**DEFENSE NUCLEAR FACILITIES
SAFETY BOARD**

September 15, 2021

HANFORD TANK FARMS SAFETY BASIS REVIEW

Defense Nuclear Facilities Safety Board Technical Report

Figure C-1. Mass of respirable waste released from a DST by a headspace detonation that causes dome failure. Recreated from Figure C-16 in [C-4].

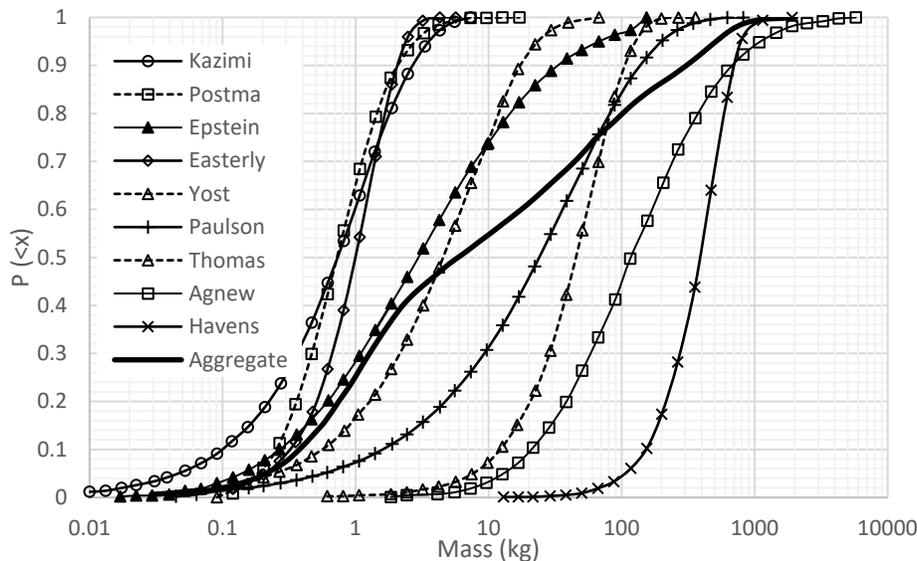
Expert Elicitation Results. The technical bases for the analyzed doses are documented in [C-2] and [C-3]. A key input into the calculations is the amount of respirable mass released as a result of a detonation or deflagration in a vessel headspace. To estimate these releases, an expert elicitation process was used. Figure C-1 below shows an example of the estimated respirable mass released due to a detonation in the headspace of a DST that results in the vessel dome failing [C-4]. Probability distributions elicited from nine experts are shown. The solid curve is the aggregate mean of the nine distributions. The vertical axis is the estimated probability that the actual value of mass released is less than a given mass on the horizontal axis. Similar curves were generated for flammable gas accidents in SSTs for which seven experts were elicited [C-5]. The DSA utilizes these aggregate mean distributions for selecting values used in dose consequence analysis.

Figure C-2. Aggregate mean respirable mass suspended/released from a deflagration accident in Hanford Waste Tanks used for on-site dose consequence analysis in DSA. DST data recreated from Figure C-15 in [C-4]. SST data recreated from Figure A3-A16 in [C-5].

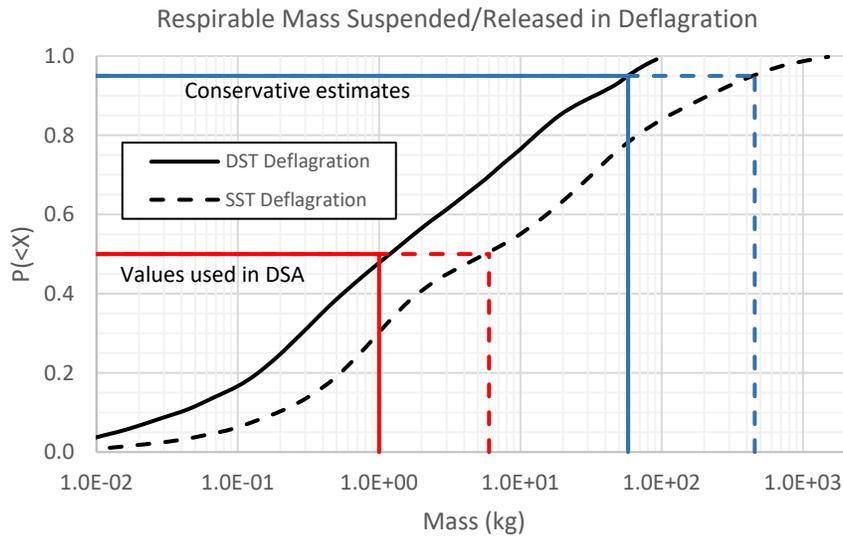
Figure C-2 below shows the expert elicitation results for aggregate mean mass released¹ for deflagration accidents in DSTs and SSTs. In applying this information to compute on-site dose estimates, the DSA used the 50th percentile estimated value of mass released. These are the

red lines shown in Figure C-2, corresponding to a mass of 1.0 kg for DSTs² and 5.7 kg for SSTs (which the DSA rounds up to 6 kg). The 50th percentile is the median value of a distribution and is typically considered to be the best estimate given an uncertain range of potential values. The masses corresponding to the reasonably conservative 95th percentile values of the median aggregate curves in Figure C-2 are 58 kg for DSTs and 455 kg for SSTs (blue lines in Figure C-2). These values are approximately 58 – 76 times larger than that the values used in the DSA.

Figure C-3. Aggregate mean respirable mass suspended/released from a detonation accident in a Hanford single or double shell tank from Figure C-16 in [C-4].

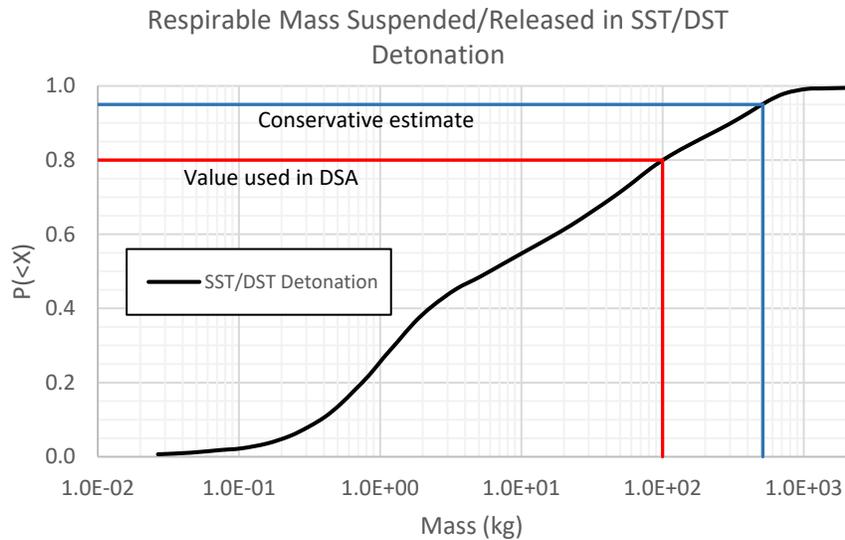
Figure C-3 below shows the aggregate mean respirable mass suspended/released for detonation accidents in an SST or DST. In applying this information to compute off-site dose estimates, the DSA used a mass of 100 kg, which is approximately the 80th percentile (the red line shown in Figure C-3) [C-3]. While the 80th percentile is a more conservative estimate than the 50th percentile used for on-site dose estimates, 20 percent of the potential values still exceed this value. The mass corresponding to the 95th percentile conservative estimate in Figure C-3 is 513 kg, which is about a factor of 5 higher than the value used in the DSA.

Figure C-4. Expert elicitation results for total mass suspended (left) and respirable fraction (right) for the deflagration accident in Hanford single shell tanks. From Figures A3-A16 and A3-A17 in [C-5].

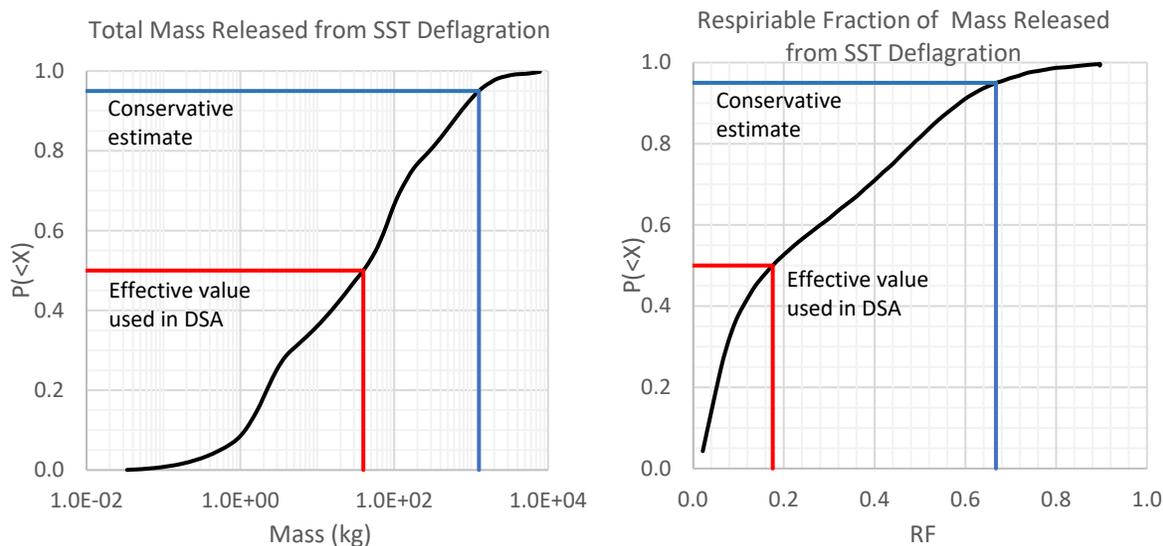
To illustrate the degree of non-conservatism resulting from using distributions for respirable mass, consider Figure C-4 below, which shows the individual distributions of total mass released and respirable fraction for deflagration events in SSTs. The respirable mass for this accident used in the DSA was shown in Figure C-2 to be 5.7 kg. The 50th percentiles for total mass released (40 kg) and respirable fraction (0.17) are shown in red in the Figure C-4. When these values are multiplied together, the respirable mass is about 6.8kg, which is close to the median value from the aggregate respirable mass distribution, suggesting the DSA effectively used median values for both total mass and respirable fraction. From Figure C-4, the 95th percentile conservative value of total mass released is 1260 kg, and the 95th percentile conservative value of respirable fraction is 0.67. A conservative estimate of respirable mass released is obtained by the product of these two conservative values³, resulting in a respirable mass released of about 840 kg. Note the additional conservatism in this result compared with the 95th percentile of the respirable mass distribution shown in Figure C-2, which was 455 kg. This additional conservatism is achieved when conservative values for each input parameter are selected, consistent with the requirements in DOE-STD-3009-1994.

A similar analysis could not be shown for DSTs since distributions for respirable fraction were not provided in the expert elicitation report [C-4]. The individual experts specified distributions of both total mass and respirable fraction, however aggregate mean distributions for respirable fraction were not provided in the report. Regardless, had the individual distributions for total mass and respirable fraction been published, it is clear that using conservative values for each would result in a more conservative (larger) amount of respirable mass, and subsequently a larger corresponding dose.
